Application Serial No. 10/734,753 Response to Office Action mailed Sep. 7, 2005

**AMENDMENTS TO THE DRAWINGS:**

Application No. 10/734,753  
 Amendment Dated December 1, 2005  
 Reply to Office Action of September 7, 2005  
 Annotated Sheet Showing Changes

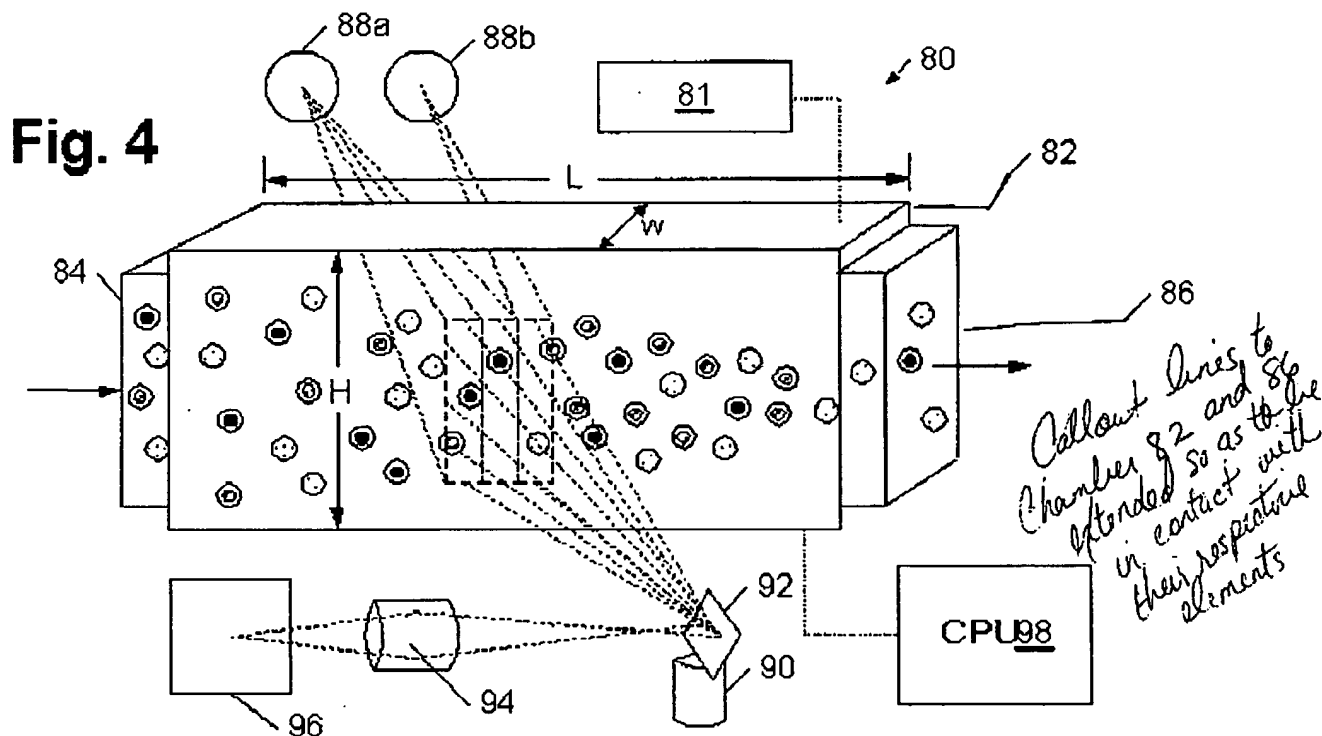
The attached sheet of drawings includes changes to FIG. 4. This sheet, which includes FIGS. 4-5, replaces the original sheet comprising FIGS. 4-5. The call out lines to chamber 82 and outlet 86 have been extended so as to be in contact with their respective elements.

In this Response, the Applicant has amended the Specification at paragraphs [0004], [0007], [0010], [0014], and [0015] to correct minor typographical errors. The Applicant amended FIG. 4 to clarify the call out lines to elements 82 and 86. The Applicant has amended claim 1 to incorporate the limitation of dependent claim 3 and has amended claim 10 to include the limitation of "fluid moving at laminar flow". No new matter within the prohibition of 35 U.S.C. § 132 has been added. The Applicant kindly requests reconsideration and allowance of the pending claims for the reasons detailed below.
